DALE DISTRIBUTING LTD.  
563 MINORU BLVD.  
RICHMOND, B. C.

BOOT GUARD ADAPTER PLATE  
TWO-PLAYER COMPUTER SPACE

Under View of  
CONTROL PANEL

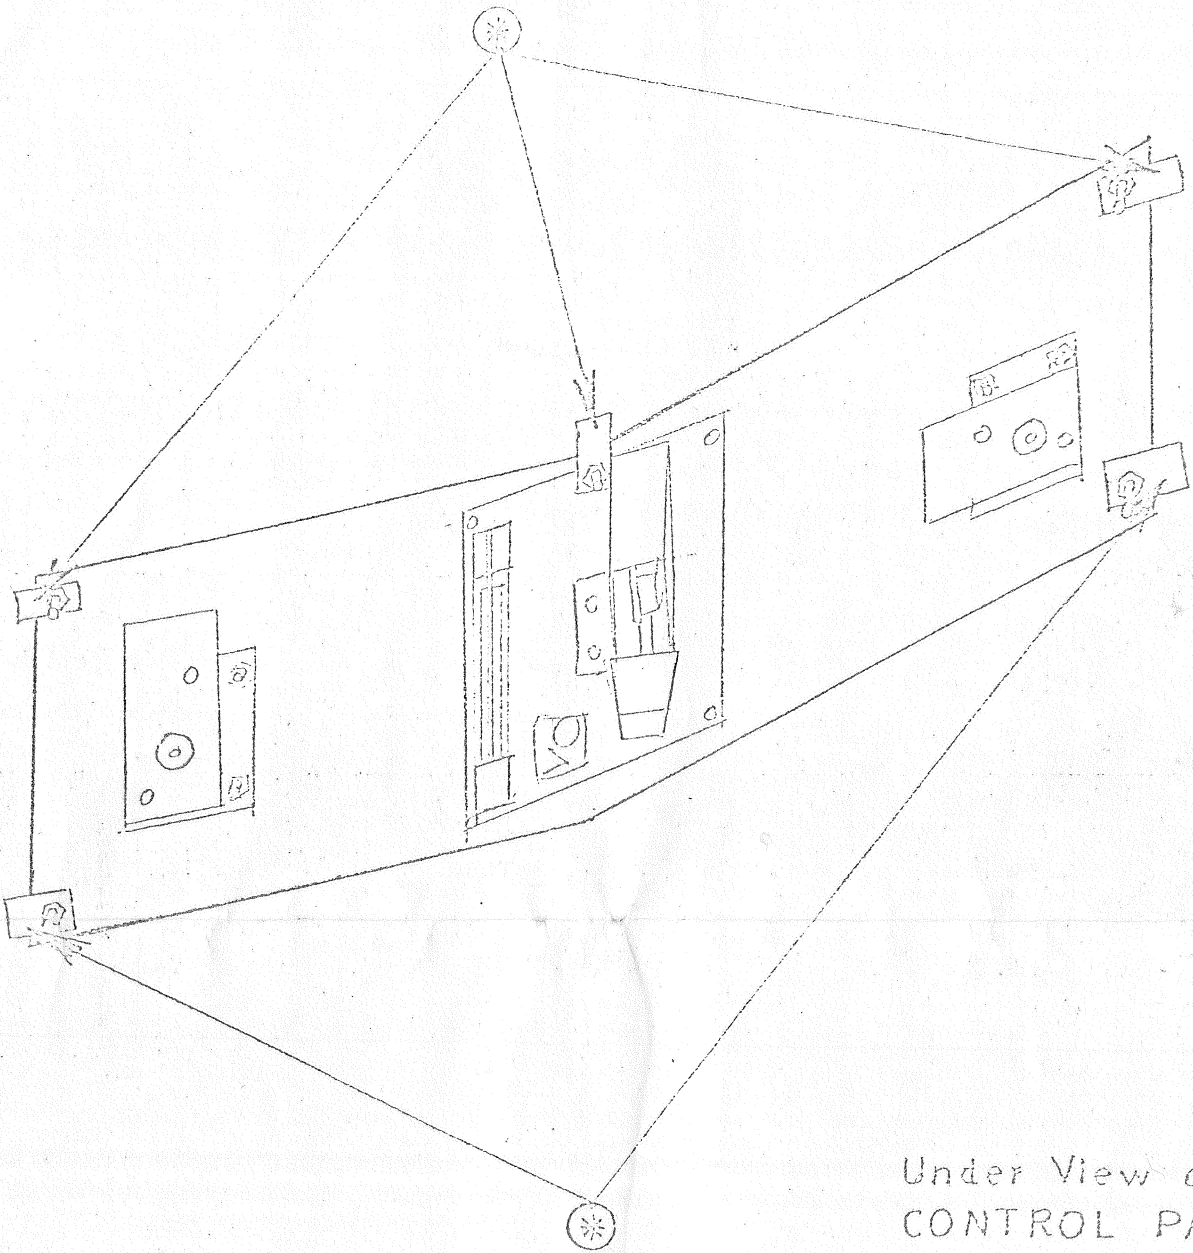
To prolong the life of the BOOT on the Two-Player Computer Space we have designed an Adapter Plate which restricts the movement of the Joystick. The Adapter Plate is made in two pieces because the Joystick hole is smaller than the large upper end of the Joystick Handle.

7. Fit the Adapter Plate over the four carriage bolts so that the hole in the Adapter Plate to which the center hole is closest goes over the bolt that is closest to the Boot hole in the Control Panel.

NOTE: The bolt hole that is closest to the center hole of the Adapter Plate is the one shown to the right in the sketch. IF THE JOYSTICK WILL NOT MOVE EQUALLY IN ALL FOUR DIRECTIONS, THE ADAPTER PLATE IS IN WRONG.
